**Roof Replacement at**  
**Scannell Readiness Center**  
**Governor Bacon Health Center**  
**P.O. Box 448**  
**Delaware City, Delaware 19706**

**ADDENDUM #1**  
**August 31, 2011**

**Delaware National Guard**  
**Project No. 08-2011**

The following document is intended to amend the Project Manual and Drawings (dated August 4, 2011) for the above-referenced project.

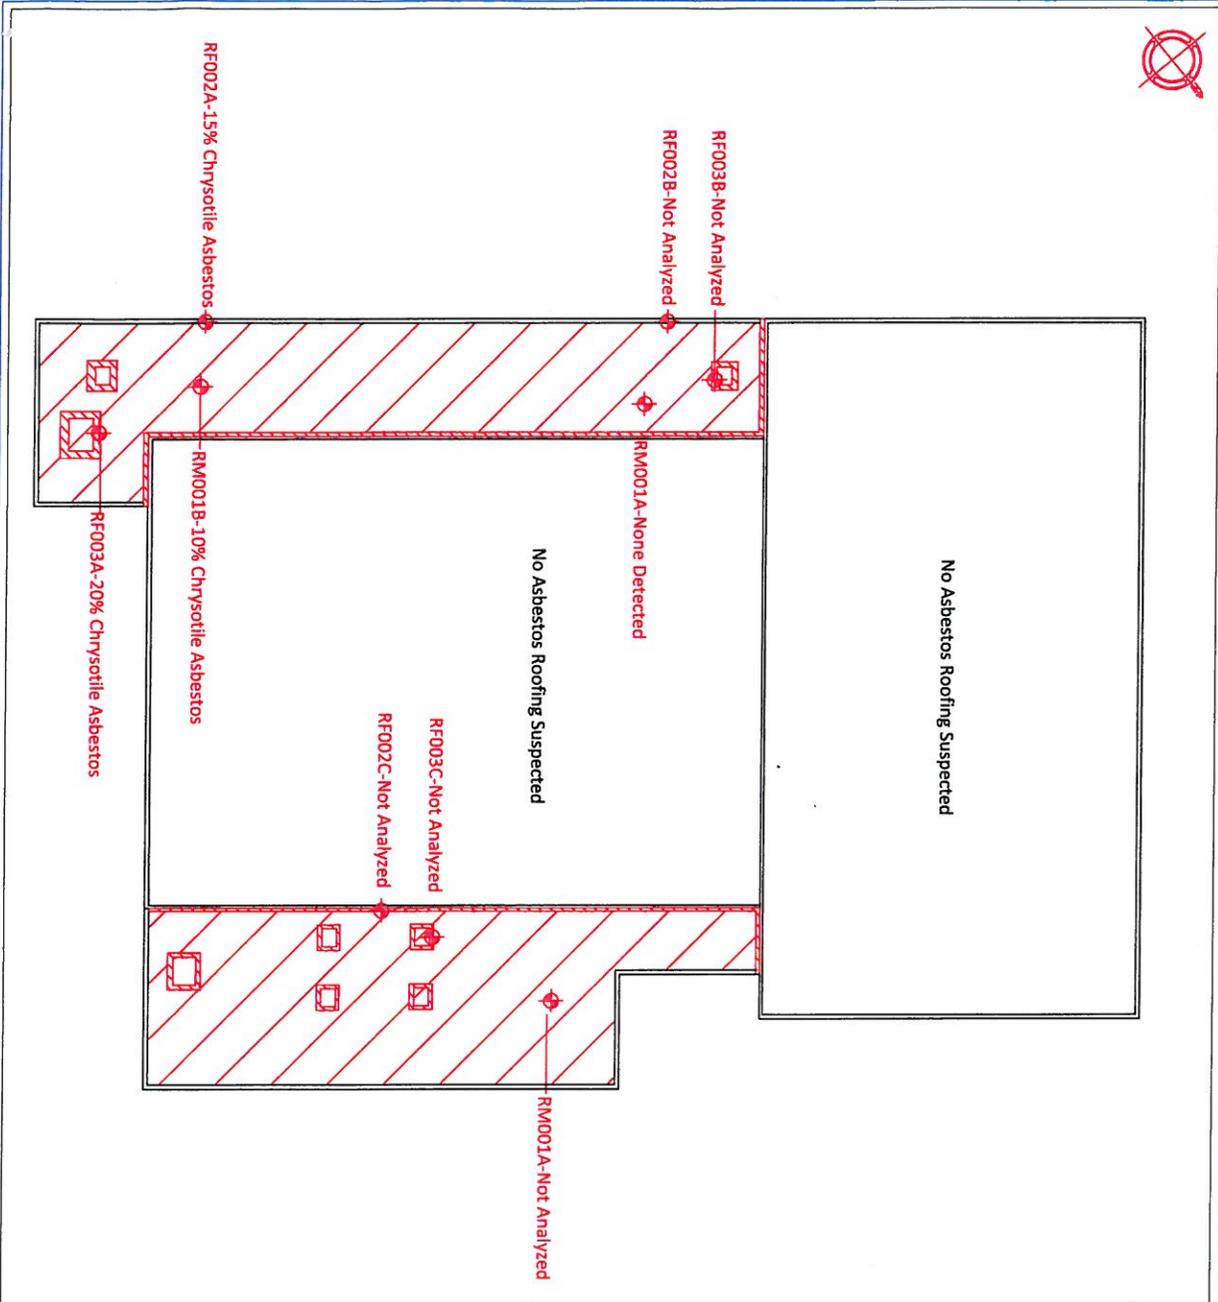
20. An environmental inspection and report has been done by Harvard Environmental and is on file. There are asbestos containing materials in the materials being removed within the limits of this contract. (Roof field tar – 3436 S.F. +/-; roof flashing tar – 450 S.F. +/-). All asbestos containing materials will be removed by an abatement contractor under separate contract with DNG. A copy of the Harvard Environmental Roof Plan is attached.

-  Bulk Sample Locations
-  Asbestos Containing Roof Flashing Tar (Est. 450 SF)
-  Asbestos Containing Roof Field Tar (Est. 3,436 SF)
